Core Bus Corridor 5: Blanchardstown

16th December 2020

Dublin Cycling Campaign

Figure 1 Improved Junction Design Blakestown and Blanchardstown Shopping Centre

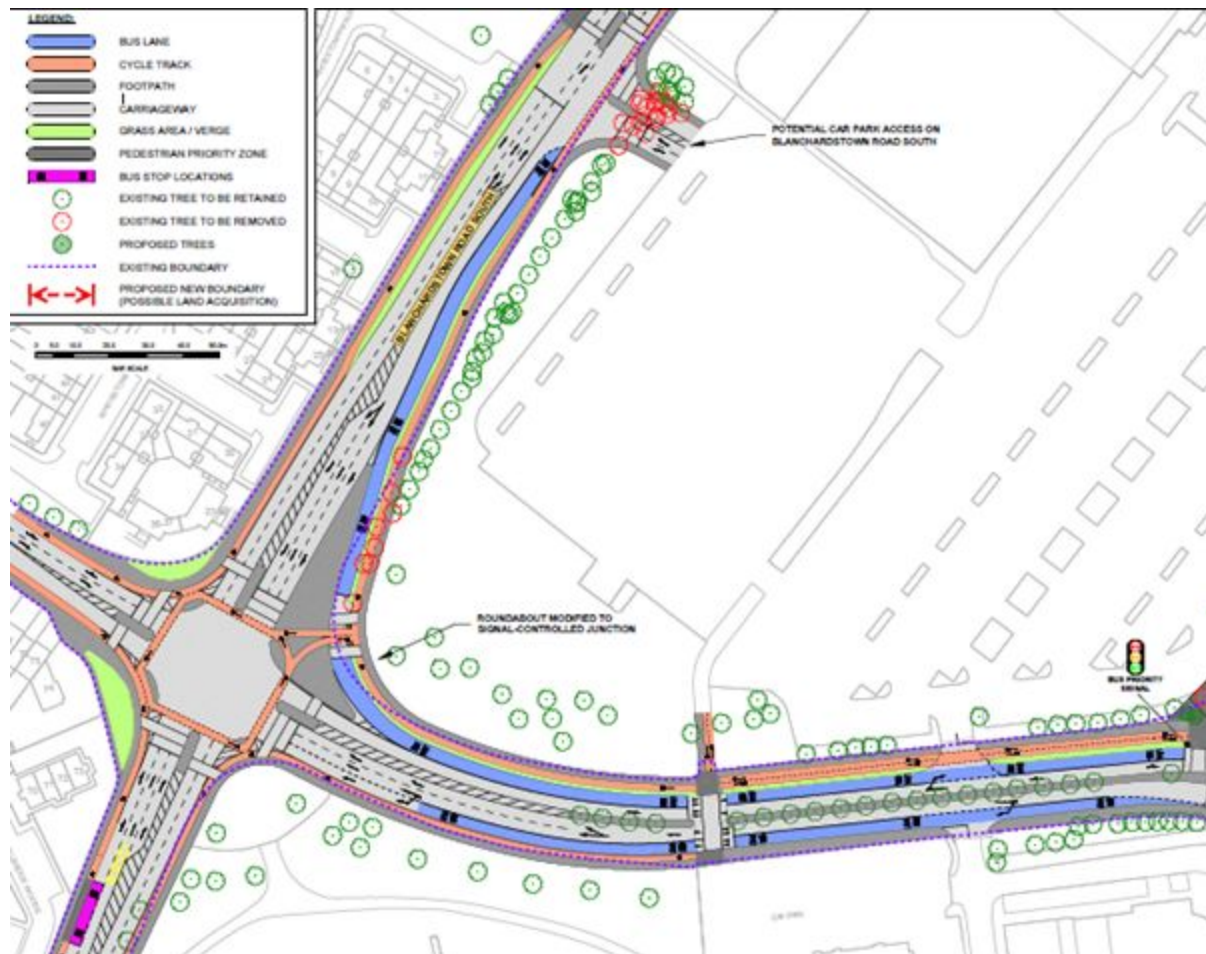
The updated design of the Blakestown Junction (Figure 1) to accommodate more cycling movements in all directions is a welcome improvement over the previous

designs. Removing the cycling hostile roundabout and implementing a segregated design approach dramatically increases the usability and safety for cyclists at this junction.

Figure 2 Reduction in Shared Space at Cabra Garda Station

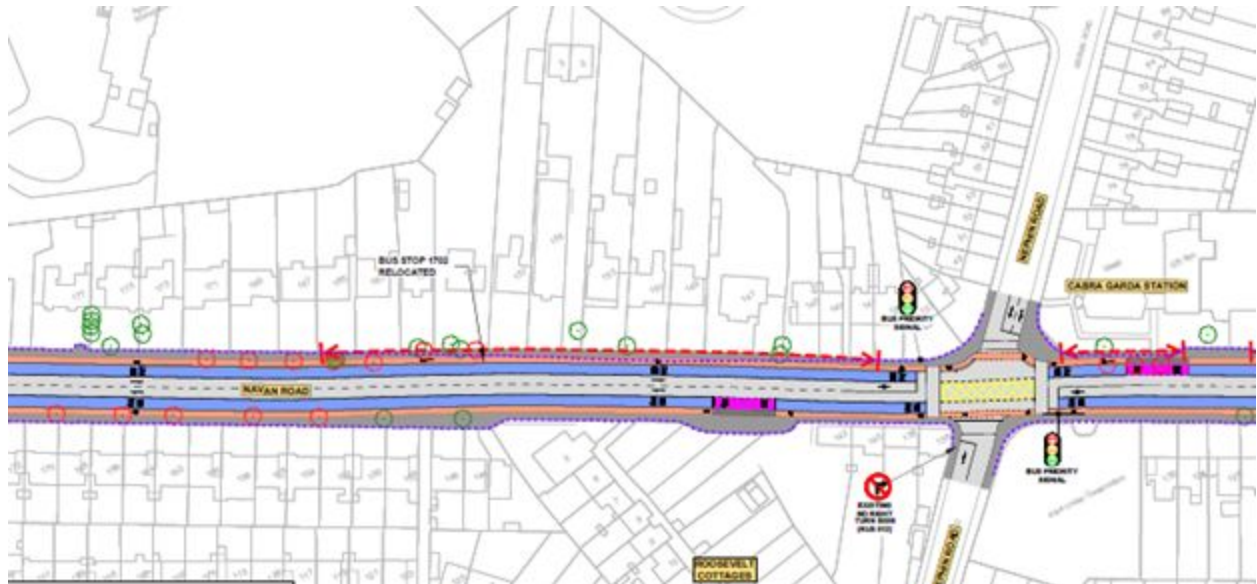
The reduction of shared space between pedestrians and cyclists at the junction at Cabra Garda Station (Figure 2) is a substantial improvement over the previous iteration.

Removing shared space between pedestrians and cyclists is recommended in the NCM Section 1.9.3. It is encouraging to see the designers endeavour to provide as much segregation as possible for pedestrians and cyclists. Furthermore, the increased segregation enables a "bus stop by-pass" at Roosevelt Cottages.

Figure 4 Illustrating Slip Lanes (Southern Portion of Blanchardstown Road Junction) Cutting Across Cycle Lanes Against National Cycling Manual Recommendations.

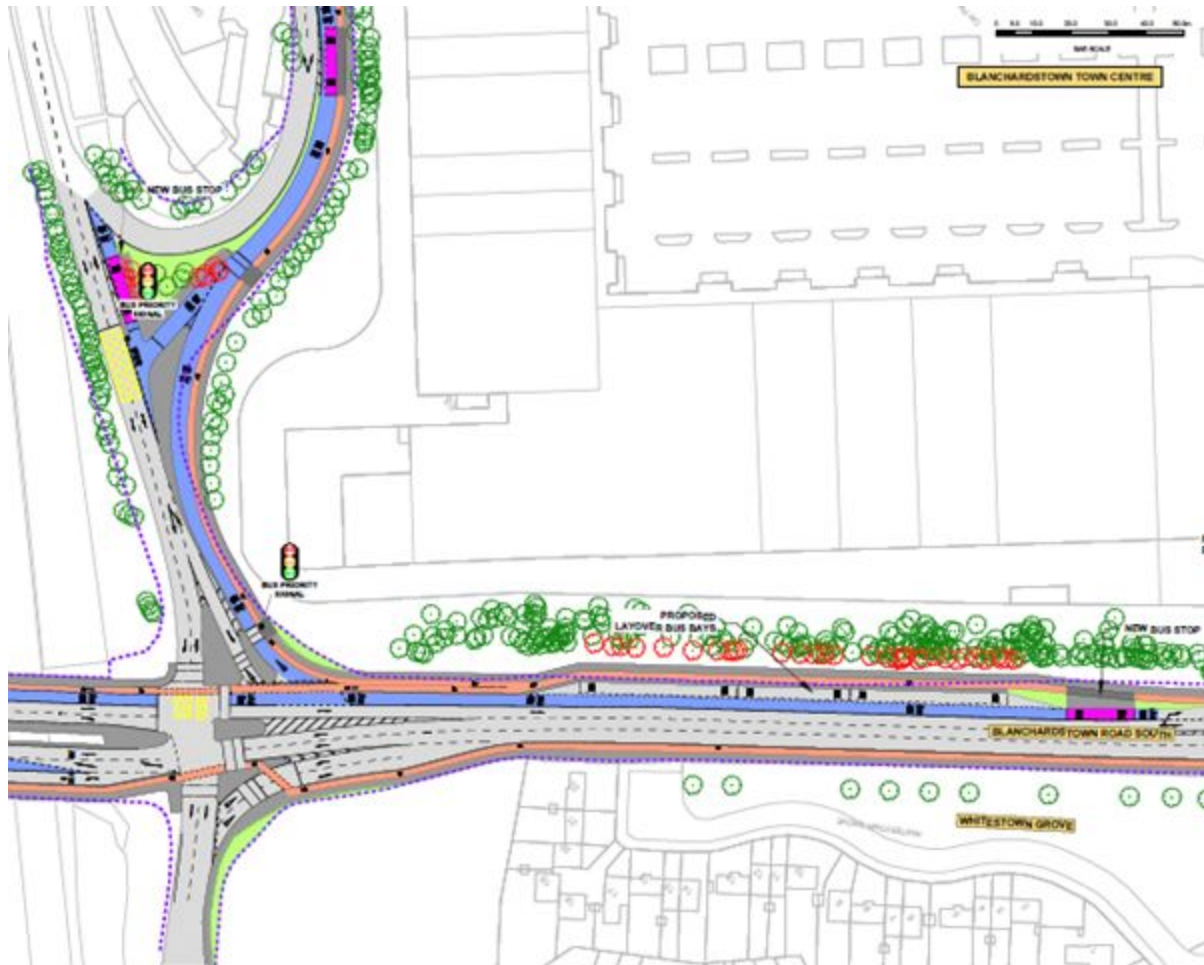
Providing cycle lanes across slip lanes is not recommended by the NTA's National Cycle Manual (section 4.4.4). These slip lanes should be removed (DMURS 4.4.3) or converted into pocket turns where complete slip lane removal isn't possible. Furthermore, these slip lanes increase crossing movements for both cyclists and pedestrians. A pedestrian wishing to cross from one side of the Blanchardstown road south, Figure 4, to the other; is forced to make five crossing movements. This clearly does not meet the objective detailed in Section 3.2 of the Transport Modelling Report:

Figure 5 Future Entrance to Edmund Rice Post Primary School (Navan Road Overpass at the Phoenix Park Racecourse)

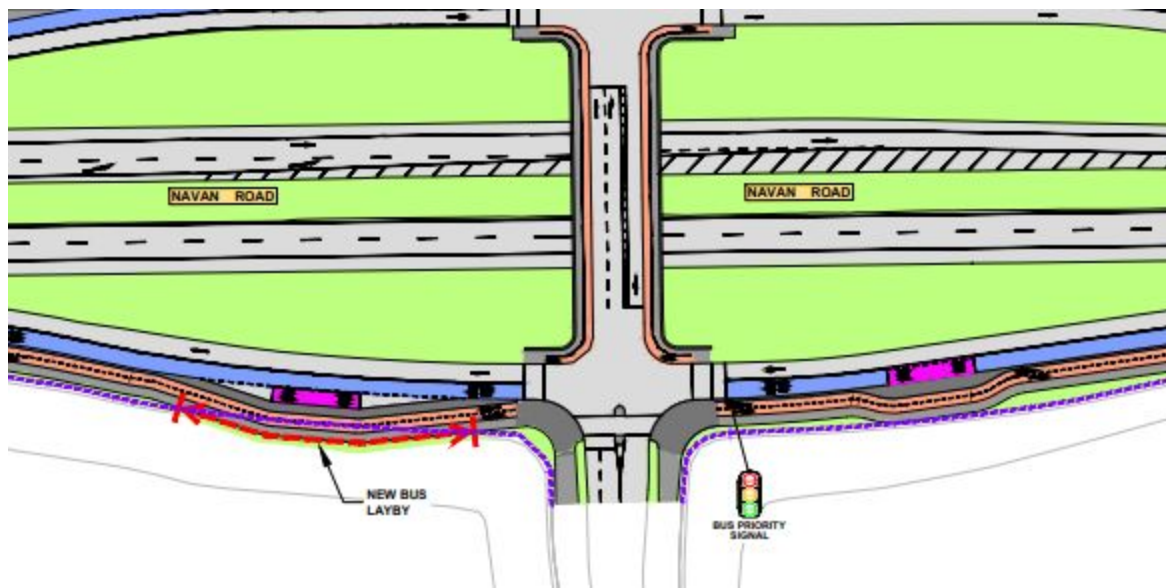
Significant shared space with pedestrians here, contradicting NCM Section 1.9.3. This junction will become the entrance to the new Edmund Rice Post-Primary school due to be completed in 2021. Consequently, cycle facilities should be kept separate from pedestrian movements and this junction should be upgraded to accommodate a 1,000 student school. Cycle and pedestrian facilities should be prioritised and segregated in accordance with the Transport Modelling Report and NCM guidelines respectively.

There should be cycle facilities designed to integrate with any cycling facilities resulting from the school's construction. A "raised entry treatment" should be strongly considered for this crossing to assert that pedestrians and cyclists do in fact have priority.

Figure 6 Entrance to Phoenix Park Avenue, Navan Road

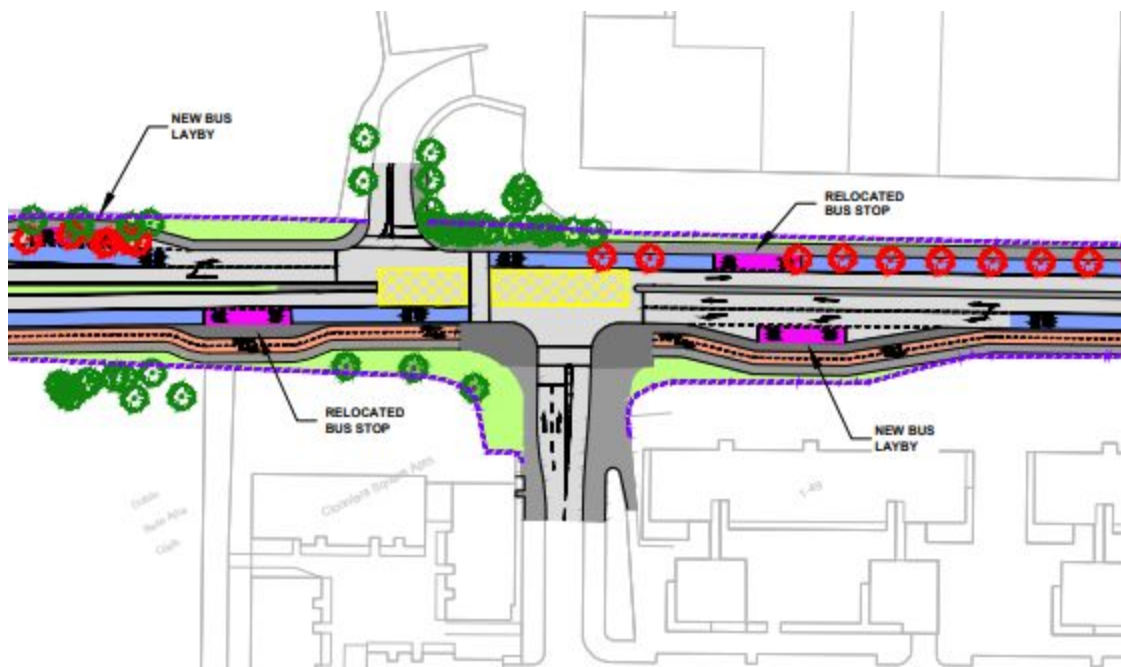
Cycle and pedestrian facilities should be prioritised and segregated in accordance with the Transport Modelling Report and NCM guidelines respectively. A "raised entry treatment" should be strongly considered for this crossing to assert that pedestrians and cyclists do in fact have priority.

Figure 13 Schematic Illustrating Width of Queen Street using ImageJ Software Analysis

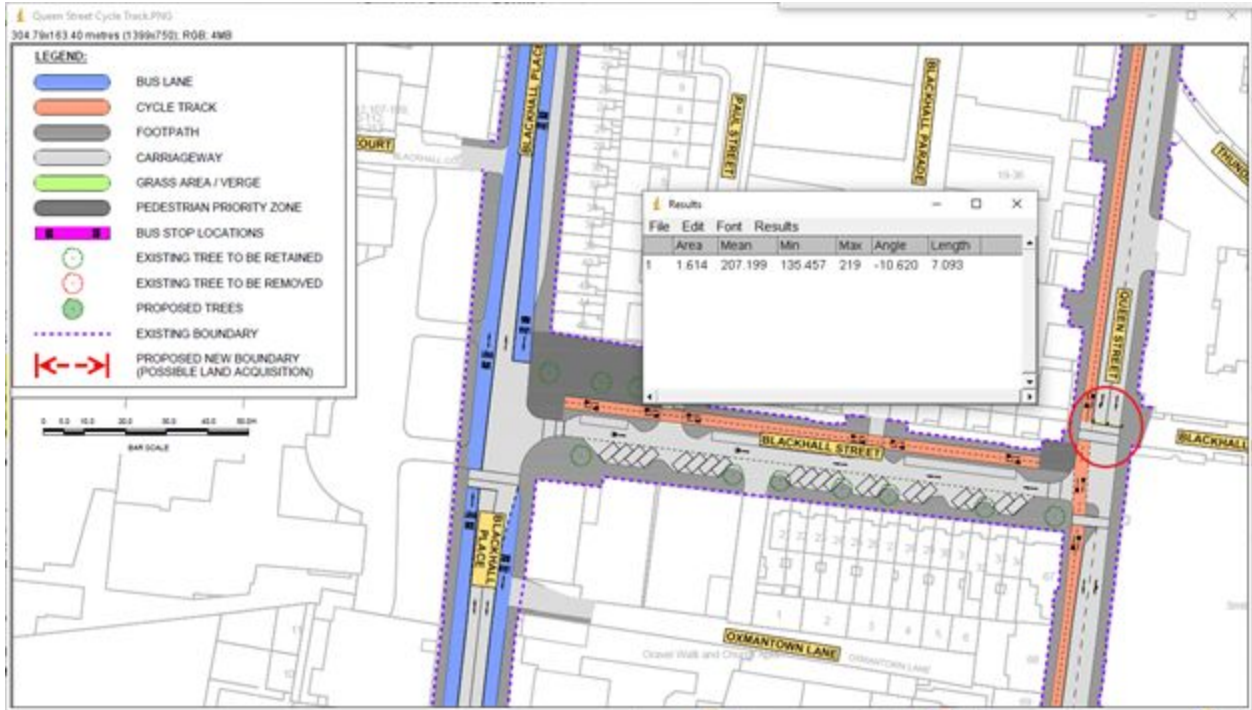
The 2.8m (Figure 14) bufferless bidirectional cycle track proposed for Queen Street is too narrow, particularly at junctions. The widths were measured using ImageJ Software Analysis (Rasband, W.S., ImageJ, U. S. National Institutes of Health, Bethesda, Maryland, USA, <https://imagej.nih.gov/ij/>, 1997-2018.) Figure 13 shows that the road width for motor vehicles on Queen St is 7m. This equates to two 3.5m vehicle lanes on a street that is supposed to prioritise the movement of people rather than vehicles (Section 3.2 Transport Modelling Report).

An alternative option would be to reduce the number of traffic lanes from 3.5m to 2.8-3m each. Queen Street is a 30km/h road with only one traffic calming measure (kerb build-out after Blackhall Place Junction). Reducing the traffic lane width would provide consistent traffic calming along the entire route. The extra 50-90cm should be used to widen the cycle track and install a buffer. Furthermore, cycle lanes will be provided on Liam Mellows Bridge to link Queen St and Bridgefoot St. Consequently, there will only be sufficient space for one traffic lane. Heuston Station bound traffic will be required to be diverted down Blackhall St to cross the river Liffey at James Joyce Bridge.

Figure 14 Schematic Illustrating Width of Cycle Track on Queen Street using ImageJ Software Analysis

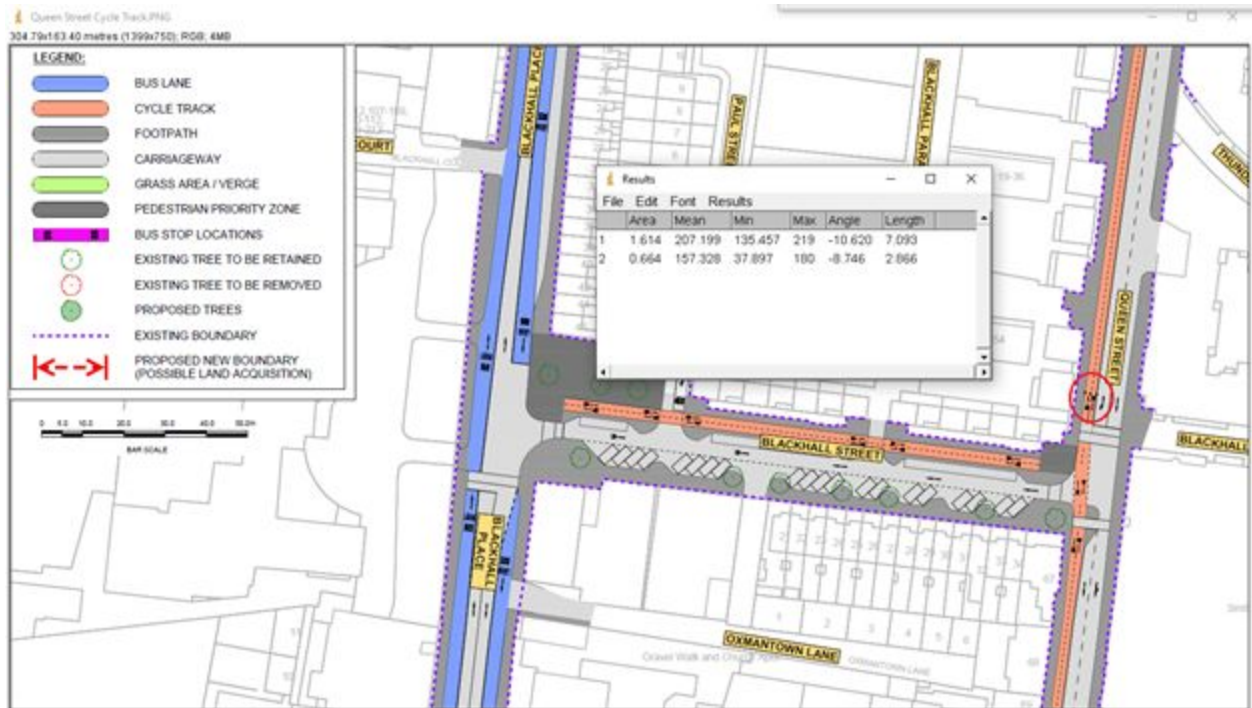
That measure will remove nearly half the traffic on Queen St beyond the Blackhall St junction. Consequently, an entire traffic lane for the relatively small number of vehicles that turn left onto the Quays is not an efficient use of that public space. Secondly, there is a missing crossing / shared space at the junction of Blackhall Street / Blackhall Place (Figure 14). This absence can be easily resolved in future iterations.
